Tarbert Ferry Terminal Upgrade Construction Licence Variation Request

Date: 27/01/2020

| DRAWING TITLE | TEMPORARY BUND PROPOSED CROSS SECTIONS |

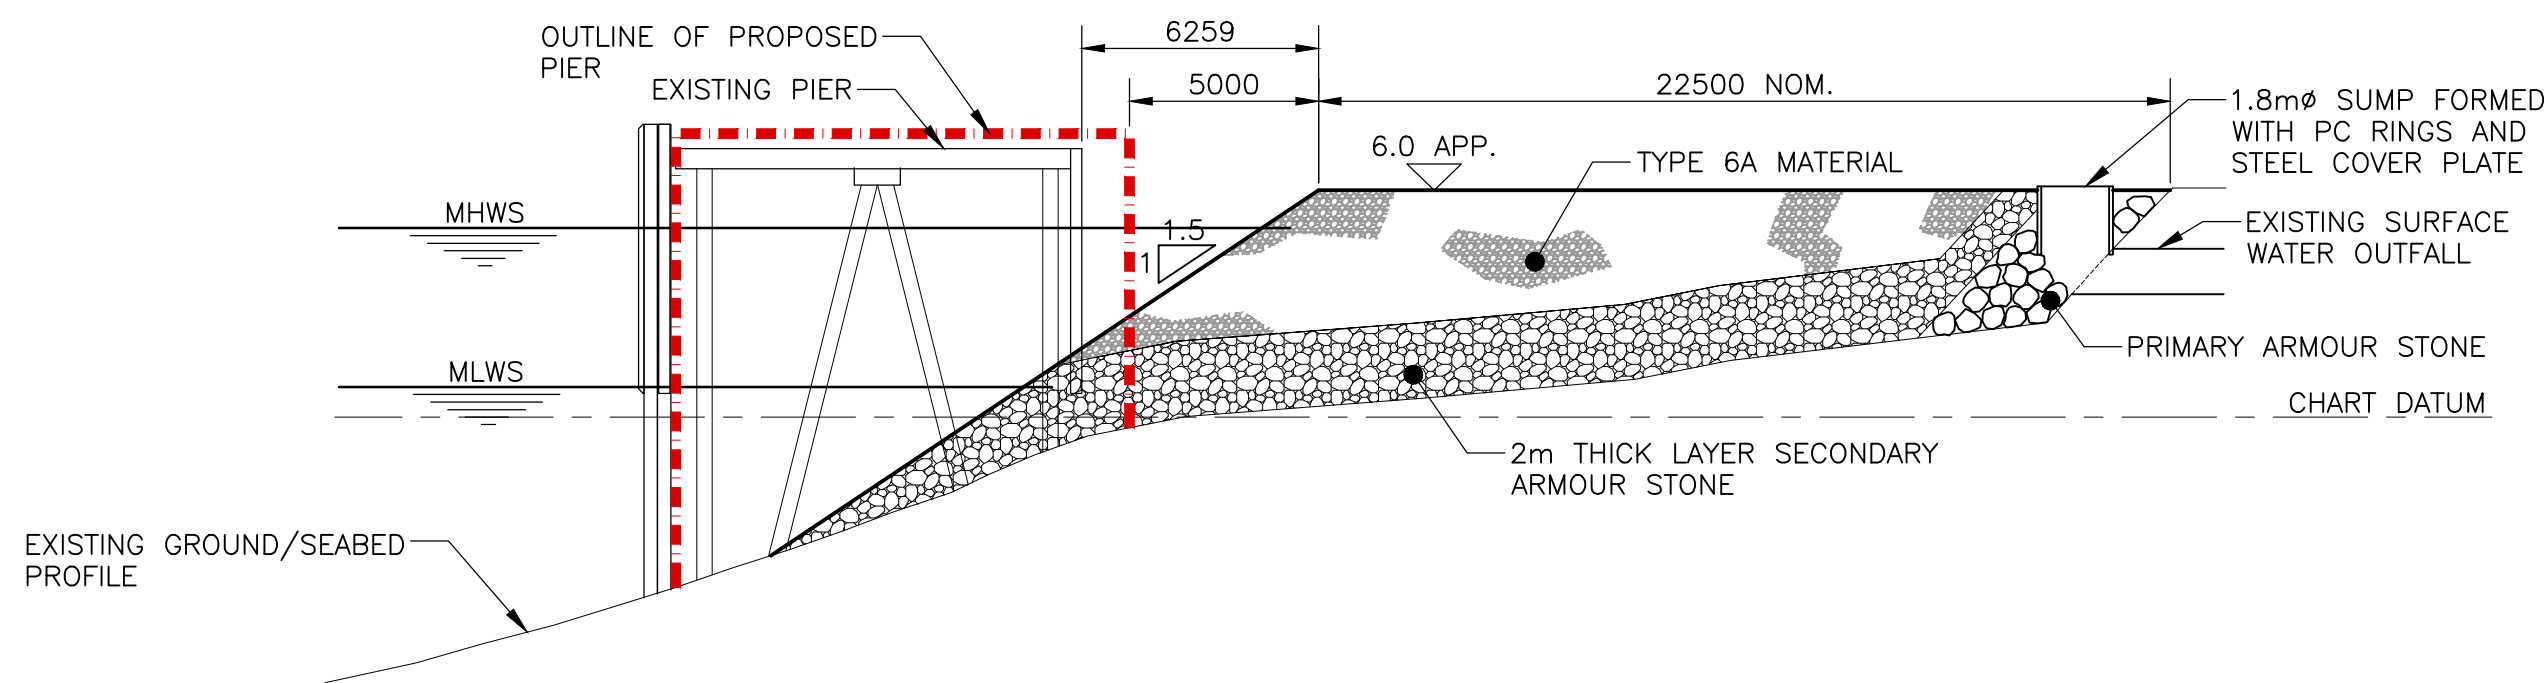
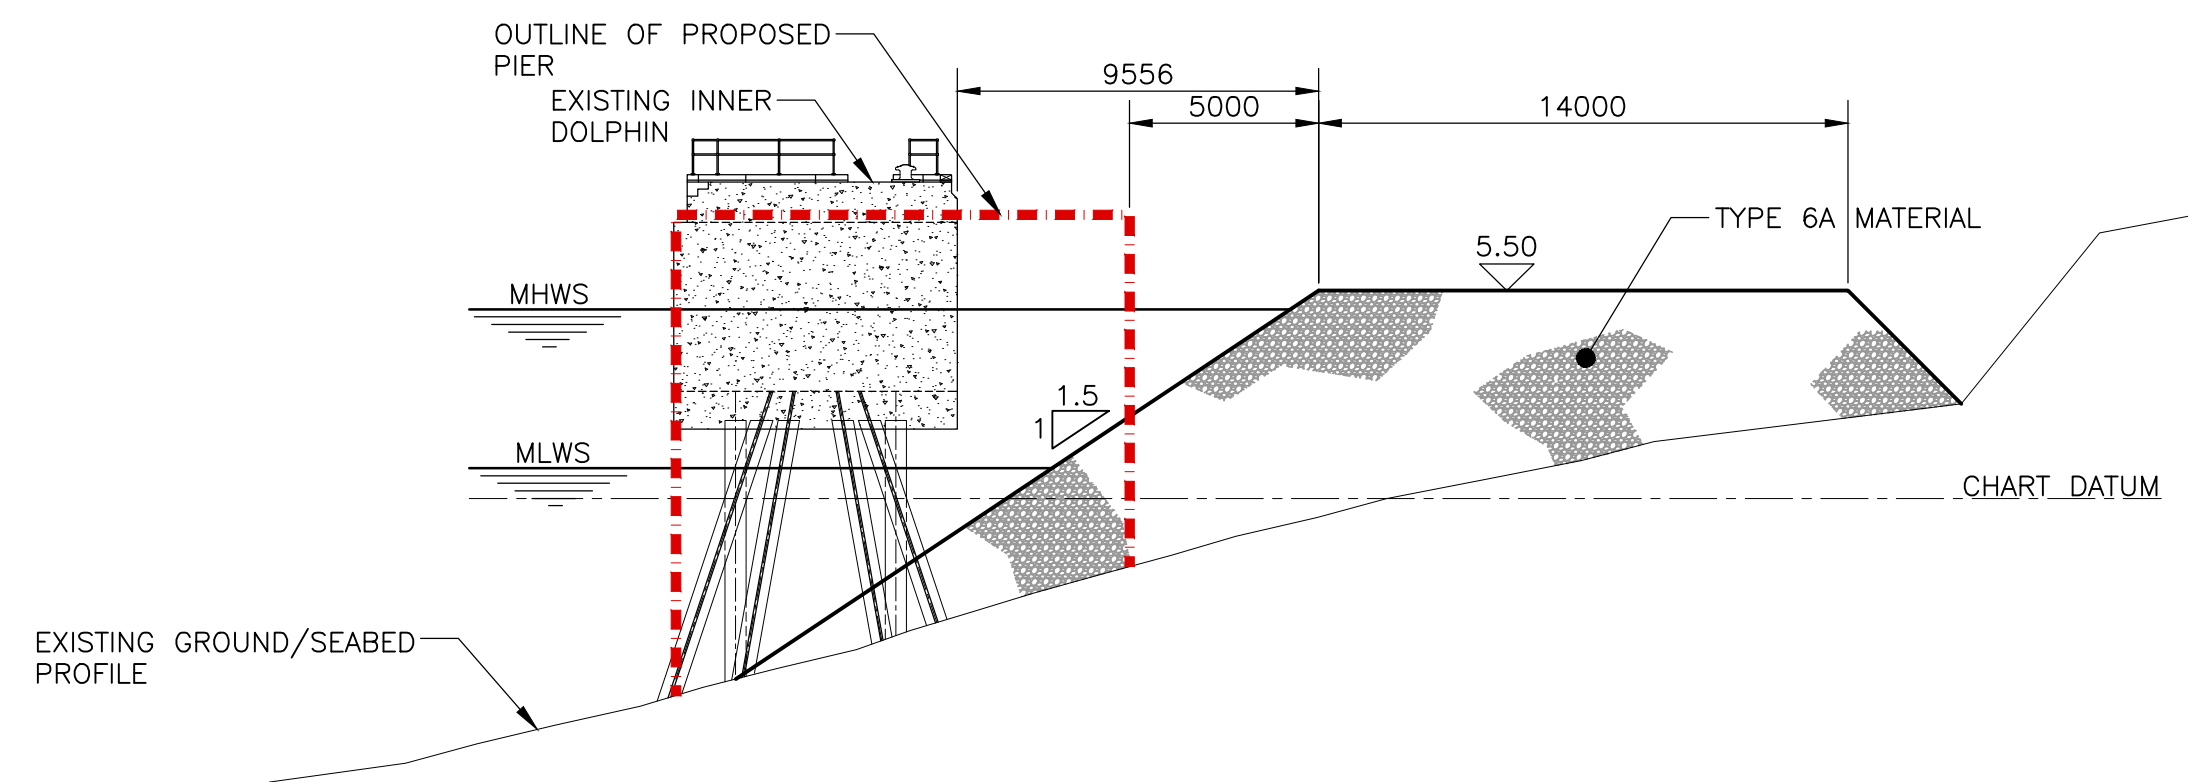
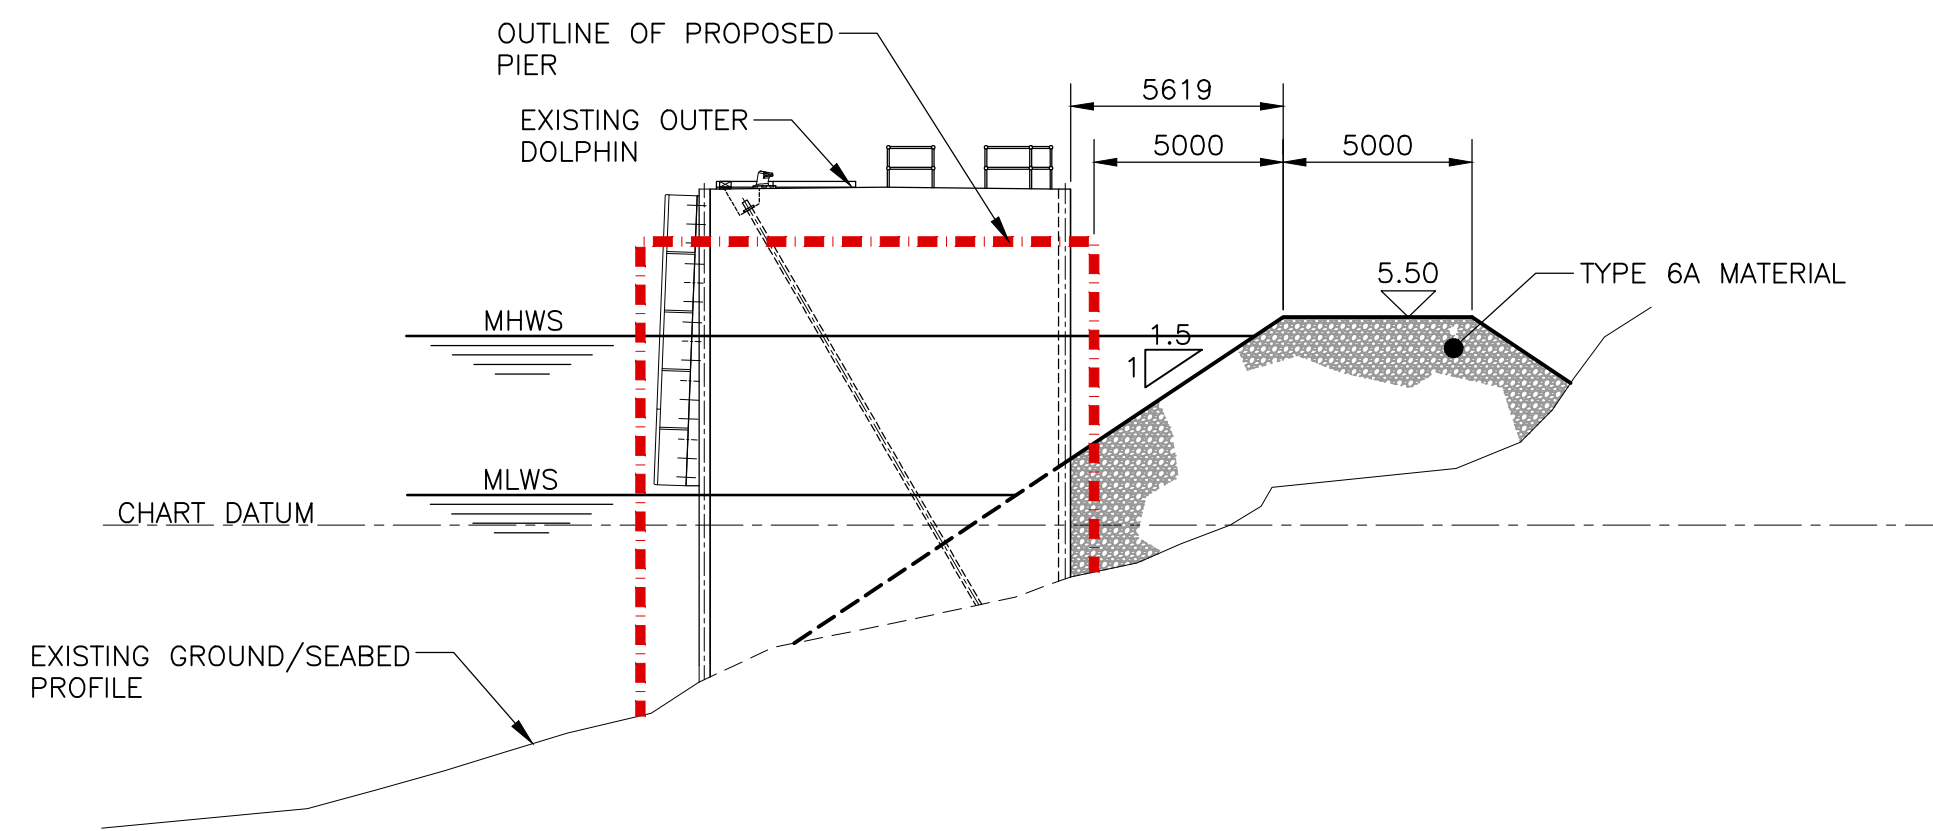
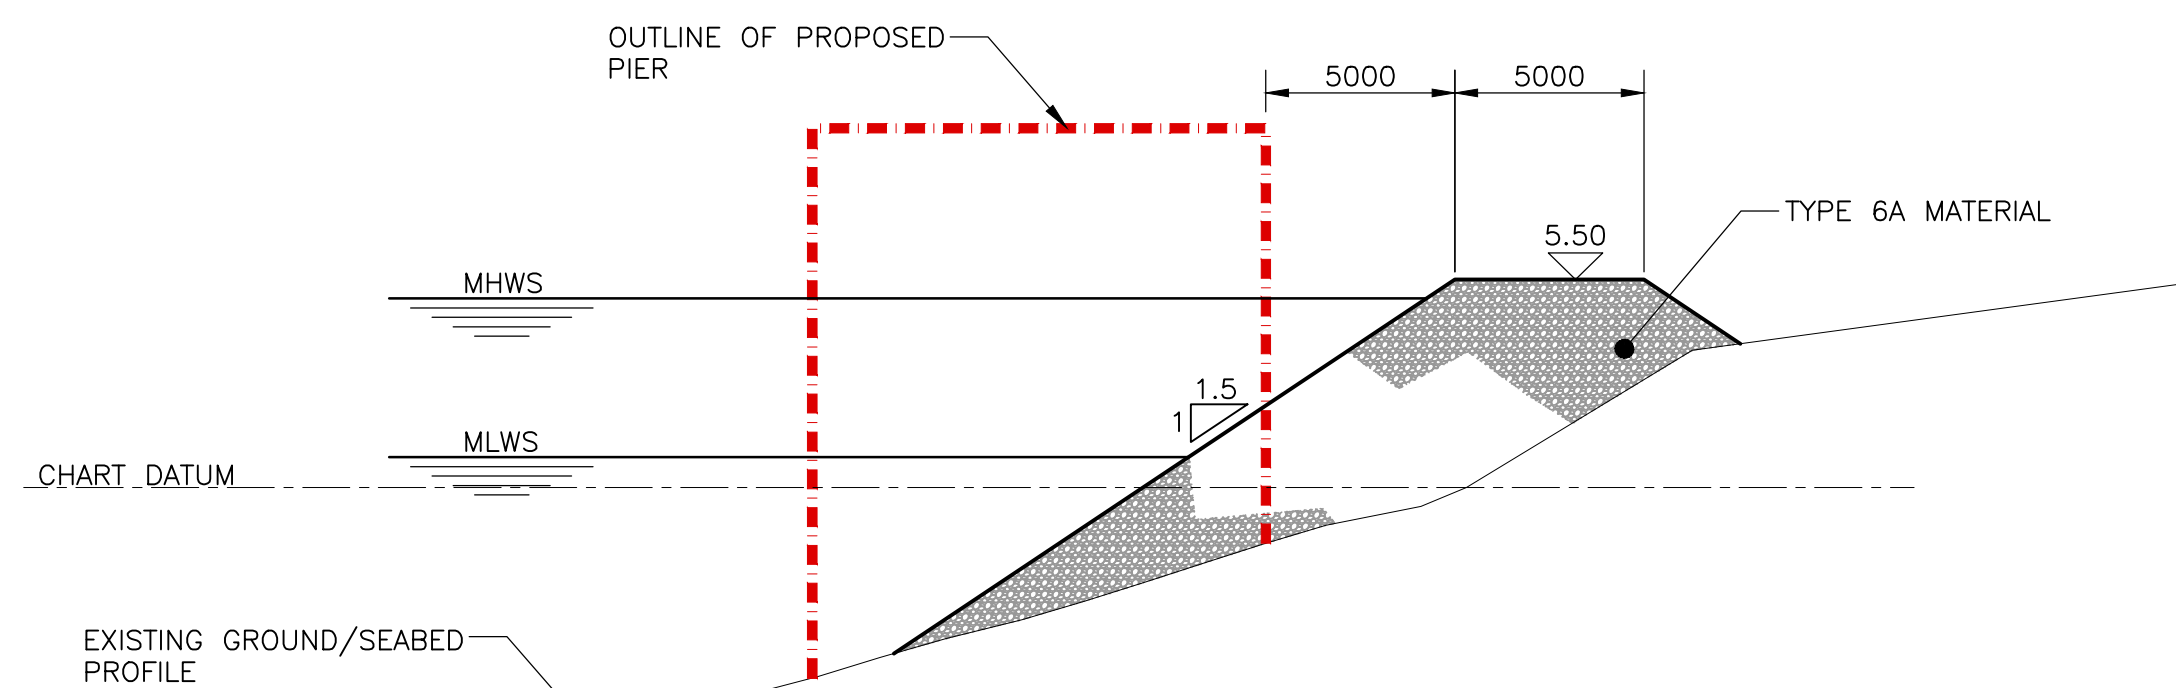
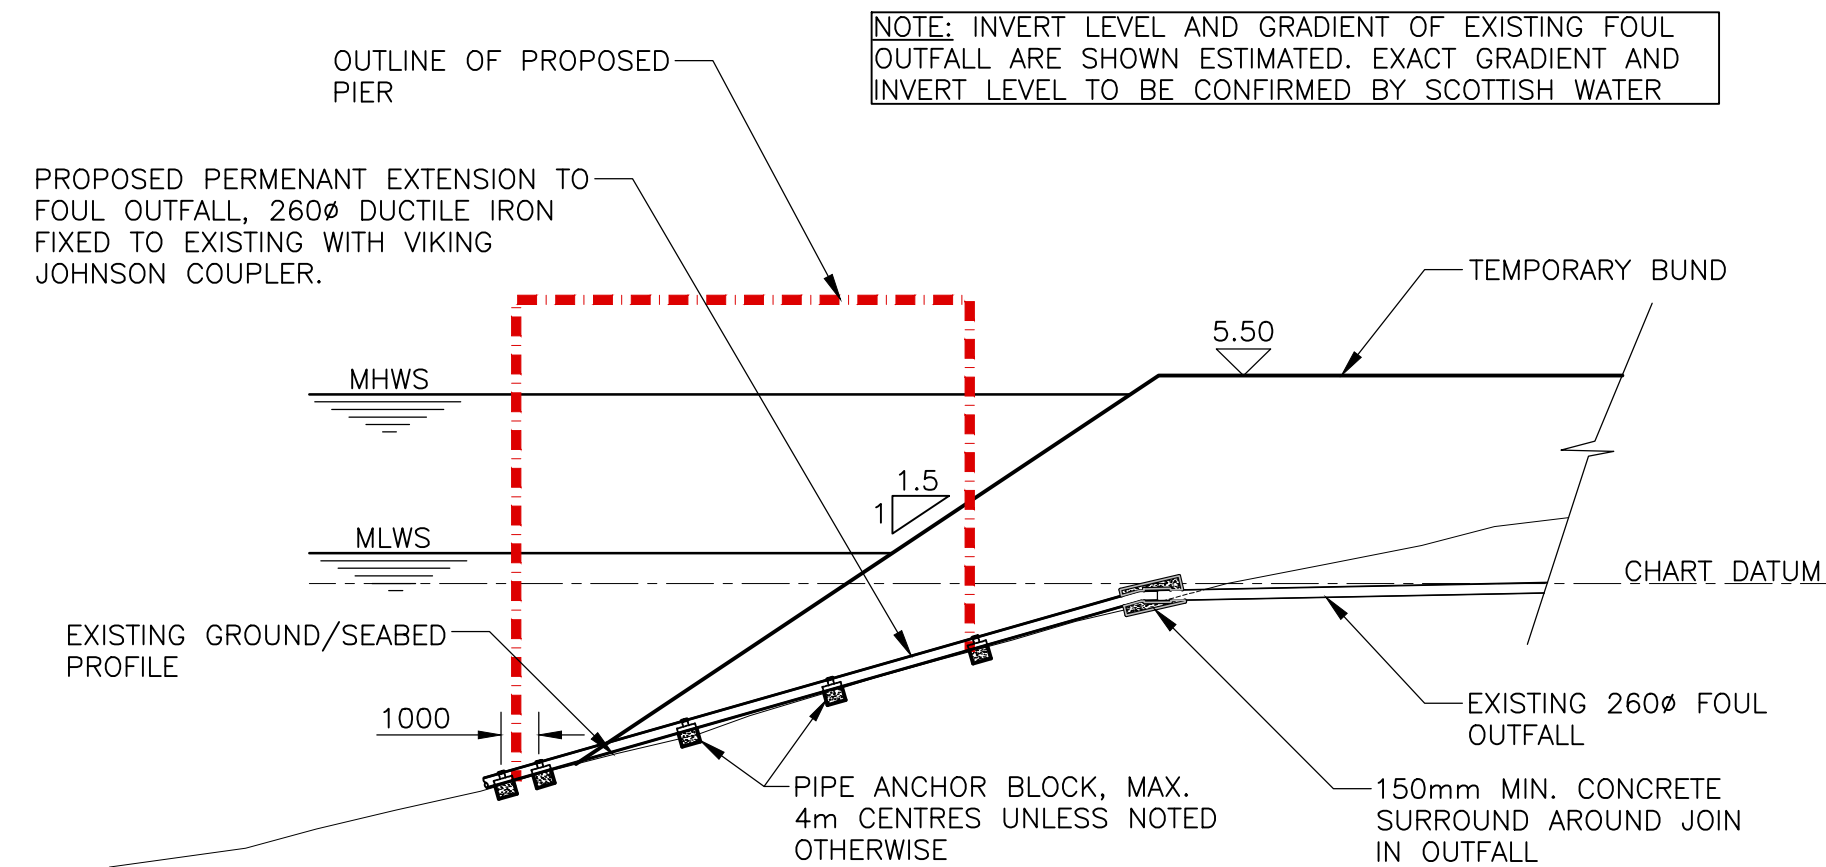
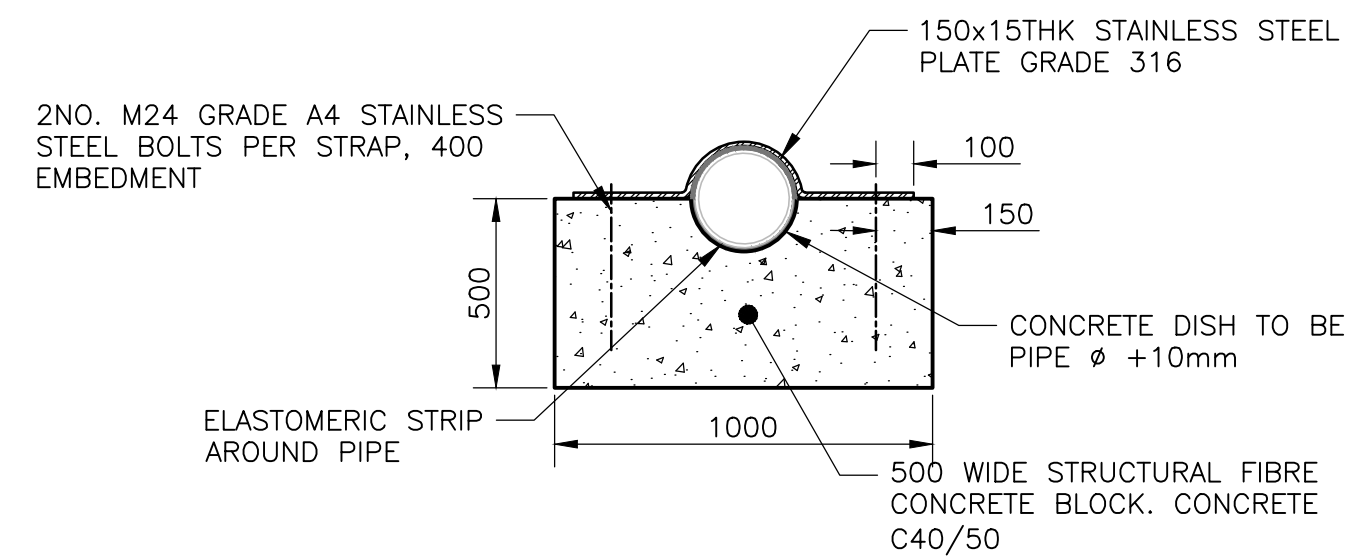
In addition, an existing outfall pipe which the infill bund would cover, is proposed to be extended out beyond the infill bund as shown in Drawing 2210-192B. Scottish Water currently have a licence issued in 1998 by the Scottish Environment Protection Agency (SEPA) under the 'Reviewed Consent to Discharge Treated Sewage Effluent to Controlled Waters under the Control of Pollution Act 1974 (as amended)' for the discharge pipe from their wastewater treatment plant. The current licence is issued to allow for the discharge of sewage effluent into East Loch Tarbert. Discussions have been held with Scottish Water who have no issues with the proposed plans.
